Water Right Conditions
Tracking Slip

FILE # # 6-17851

PUBLIC INTEREST REVIEW FOR GROUNDWATER APPLICATIONS

A. GENERAL INFORMATION: Applicant's Name: Threemile Canyon Farm County: Morrow

Water Levels in Nearby Wells (from T-11666)

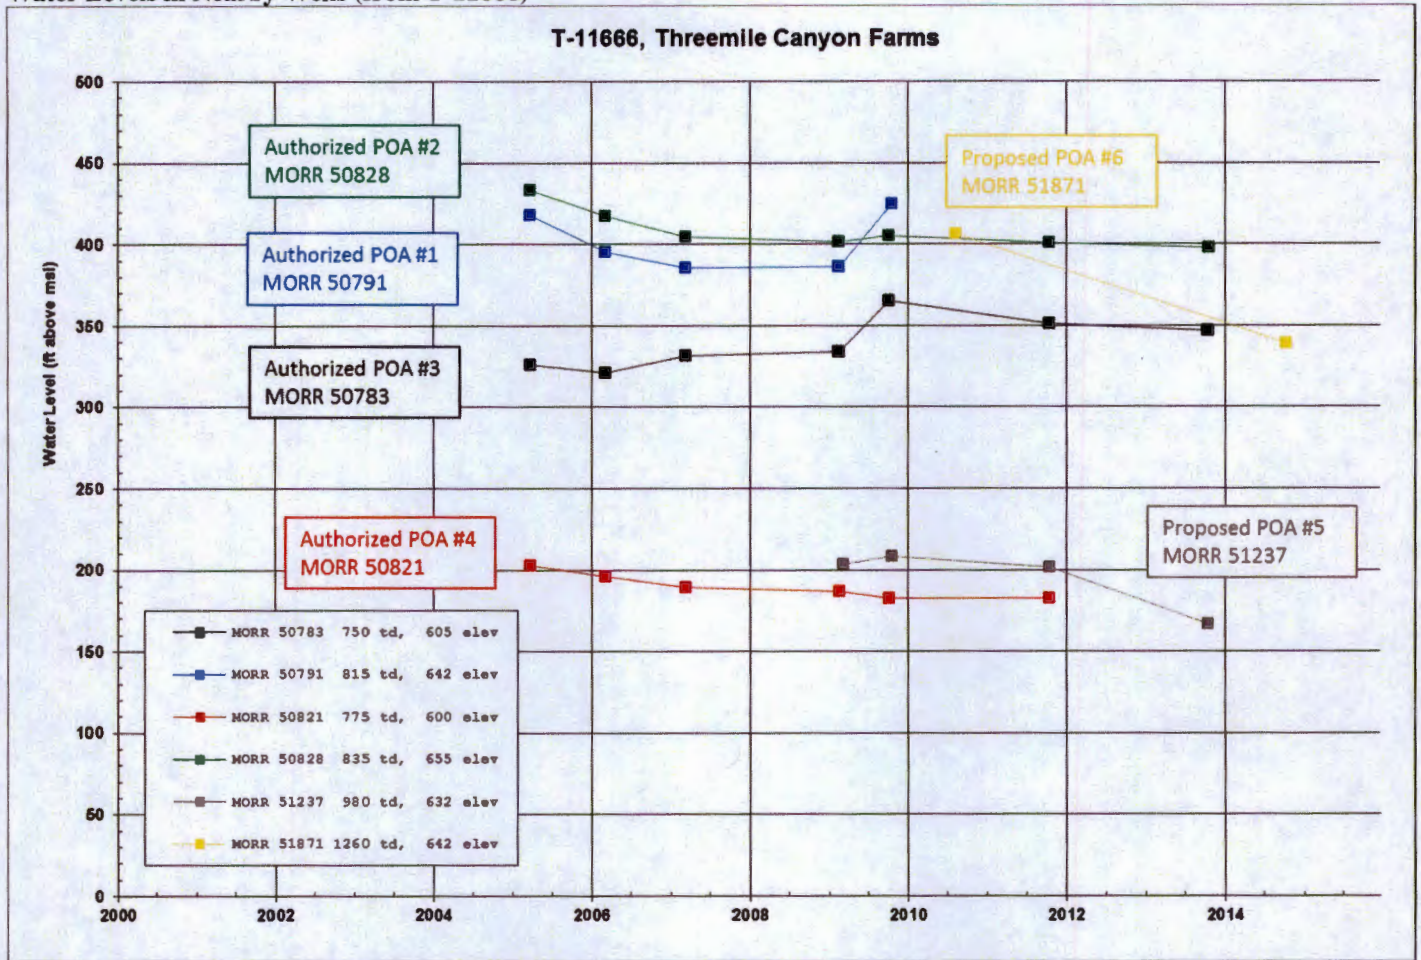
Water levels in nearby wells show no obvious signs of declines, so the resource may be able to support the additional use (see attached hydrograph).
